SOLICITATION ADDENDUM NO. 2

ITB 19-0016

GC for Barnes Elementary Wood Frame and Window Replacement

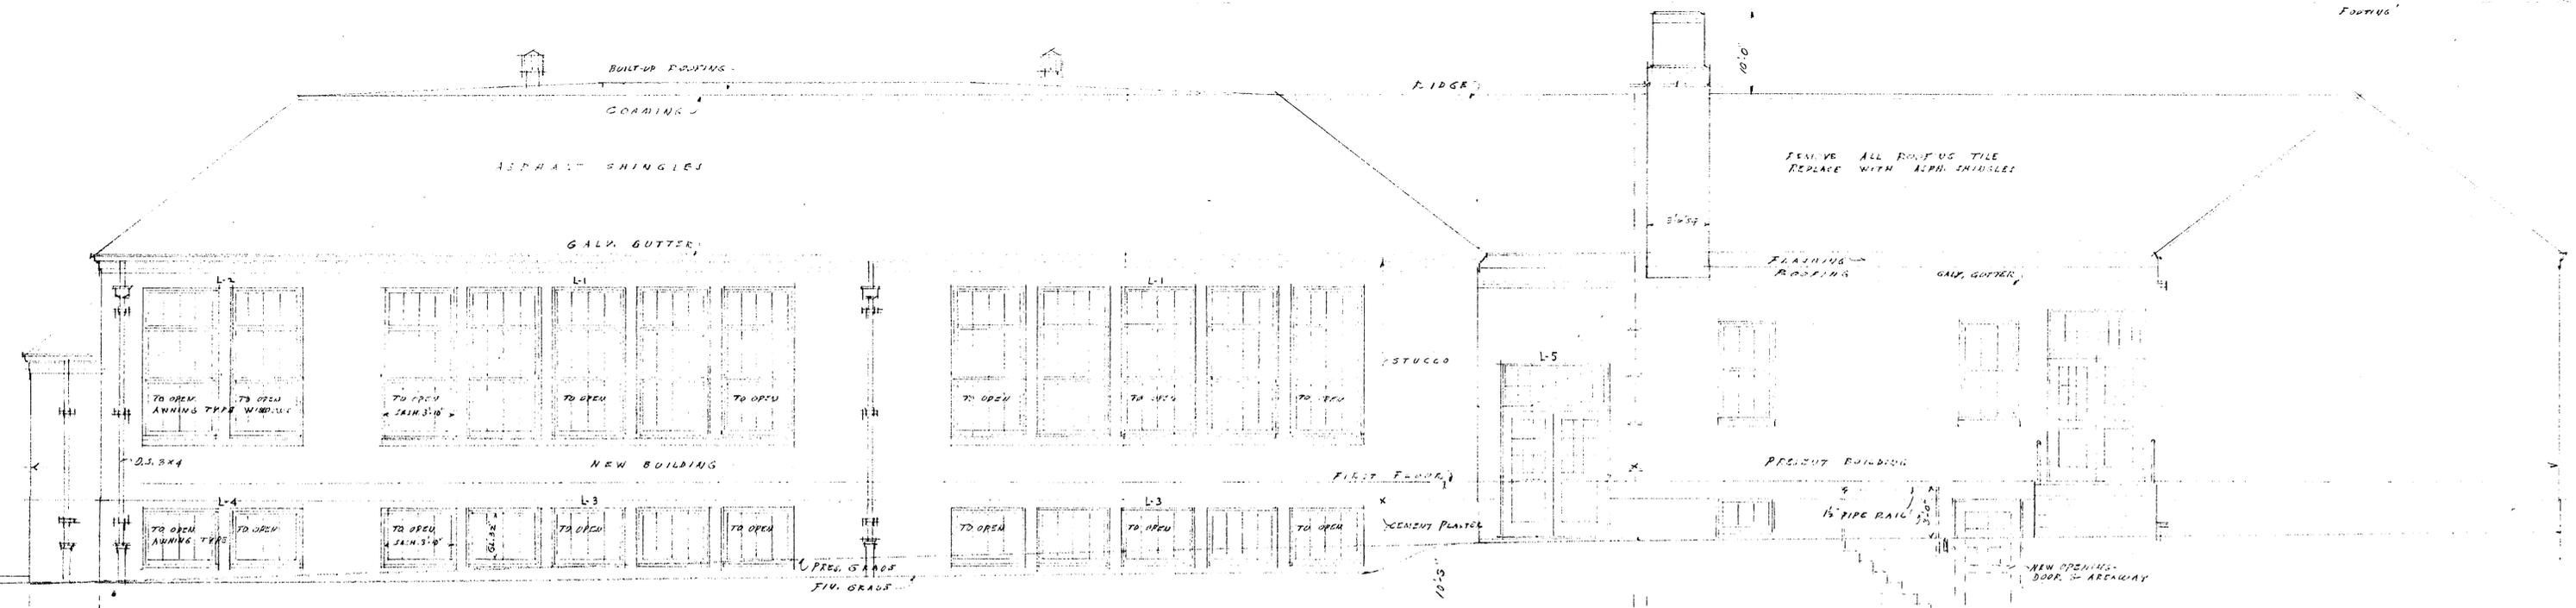
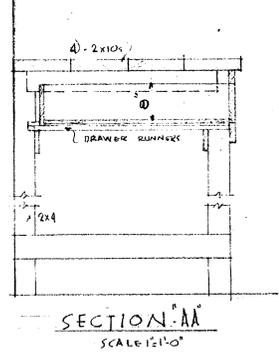
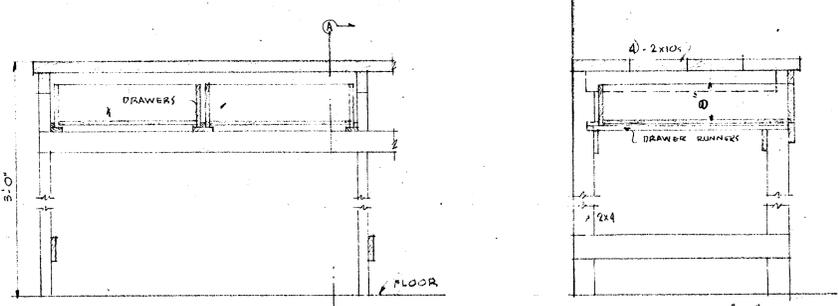
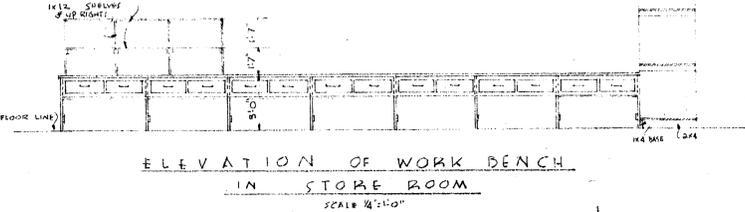
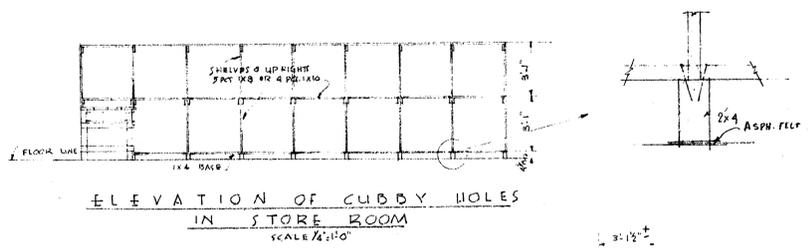
Question: Will there be any as-built plans, or any plans associated with the job released? Or is the General Contractor responsible for all field measurements?

Answer: Below are limited plans from 1947 and 1953 that show the windows as originally designed.
